Tennessee Valley Authority

NUREG-0847
Supplement No. 14

Safety Evaluation Report

related to the operation of
Watts Bar Nuclear Plant,
Units 1 and 2

Figure 5.1 Watts Bar 1, Analysis of Intermediate Shell Forging 05 Model Comparison, Service Levels A and B

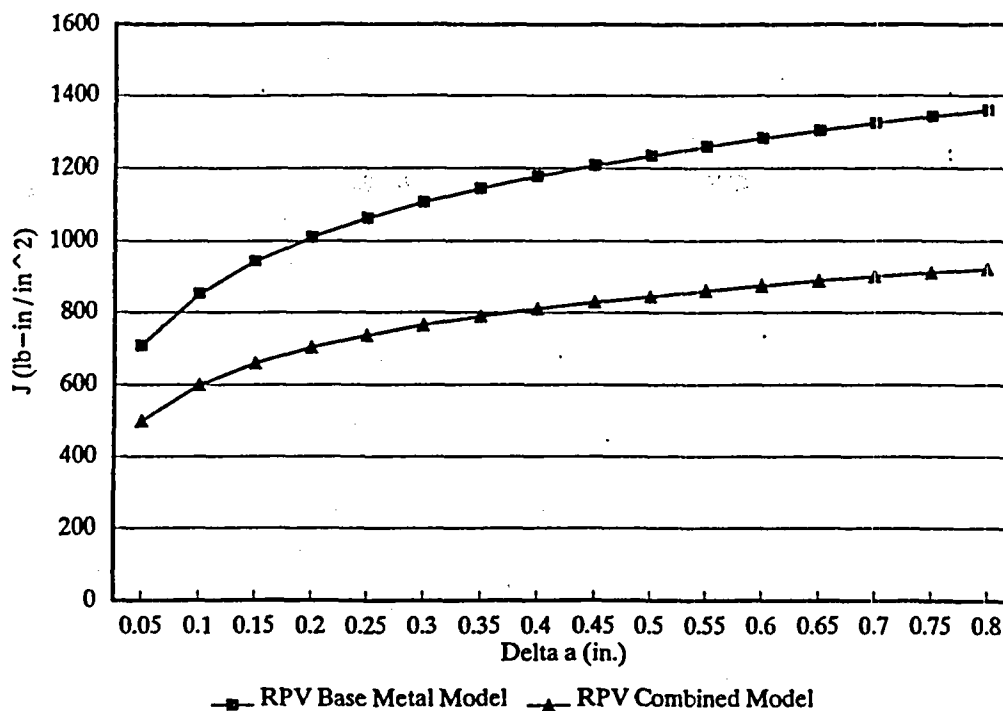
The Westinghouse report for Watts Bar Unit 1 used the 100 °F/hr heatup/cooldown case as bounding for Levels A and B. This is consistent with the evaluation performed in WCAP-13587, Revision 1. For Levels C and D, the Westinghouse analysis used both peak stress and the overall magnitude of the through-wall stress as the criteria to determine the bounding transients. The resulting temperature at the crack tip (10% of wall thickness + cladding) was 487 °F for Watts Bar Unit 1 (see letter from W. Hodges dated April 21, 1994). Using these criteria, the applicant judged that a small steamline break was the limiting Level C transient, and large loss-of-coolant accident and large steamline break were the limiting Level D transients.

Figure 5.2 Watts Bar 1, Analysis of Intermediate Shell Forging 05
Establishment of Criterion #1, Service Leves A and B, SF=1.15

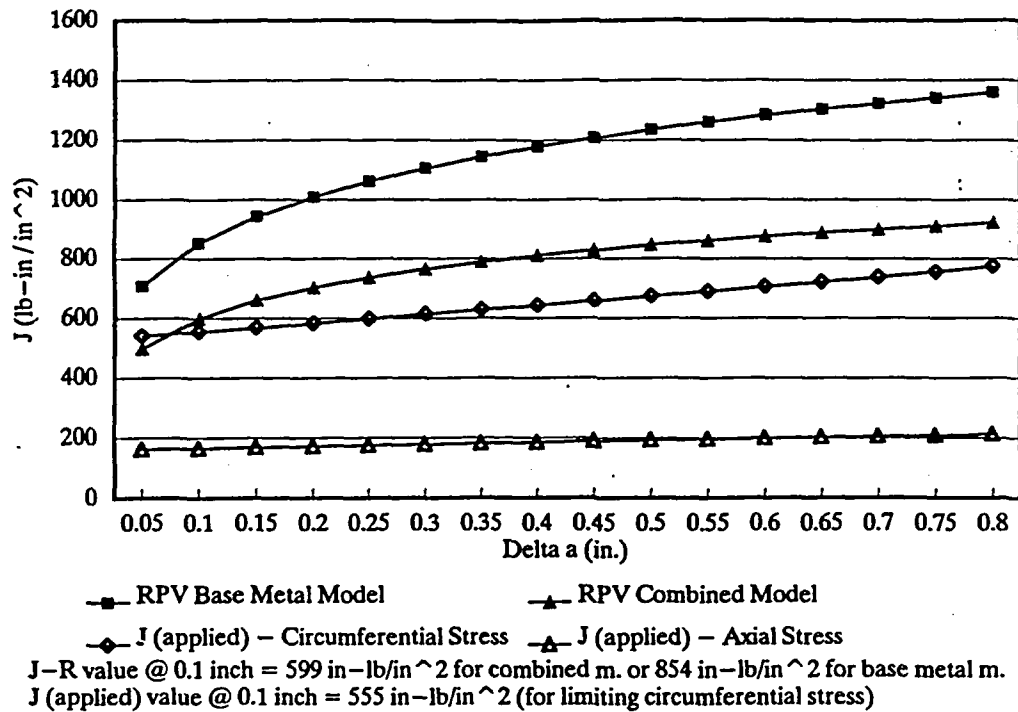
As shown in the tables and figures, forging 05 complies with the Code Case N-512 criteria for all of the conditions evaluated. The comparisons in the tables apply to the axial flaw case, which was found to be limiting. The figures show the J_{applied} curves only for the case of Equation 1.

Figure 5.3 Watts Bar 1, Analysis of Intermediate Shell Forging 05
Establishment of Criterion #2, Service Leves A and B, SF=1.25

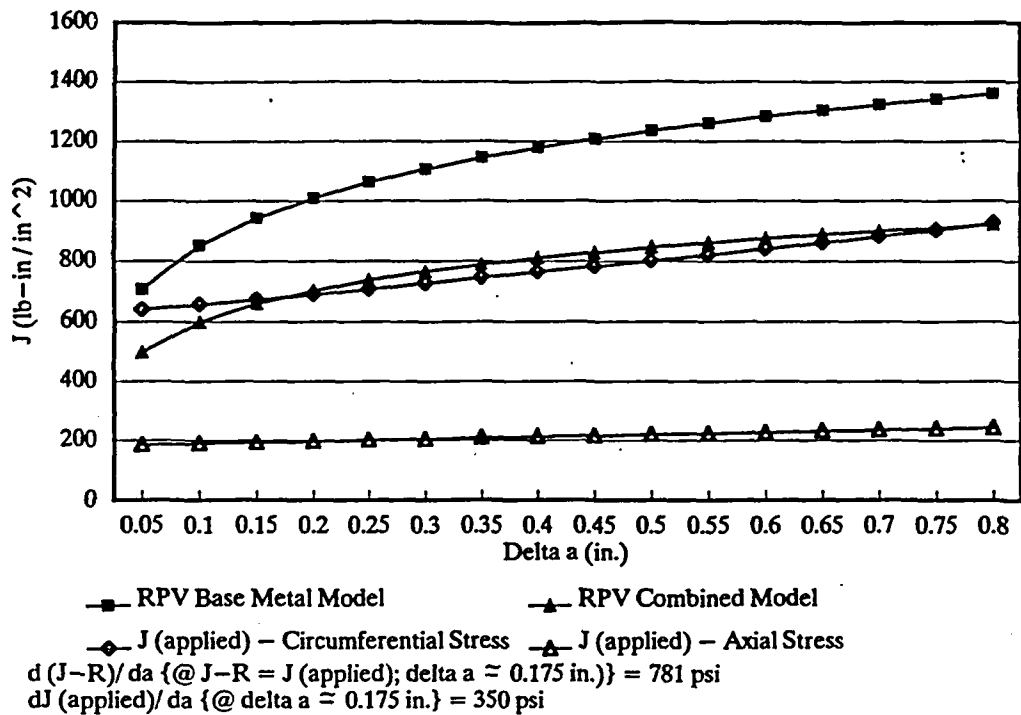
For completeness, the figures also show the J_{applied} curves for the circumferential flaw case.
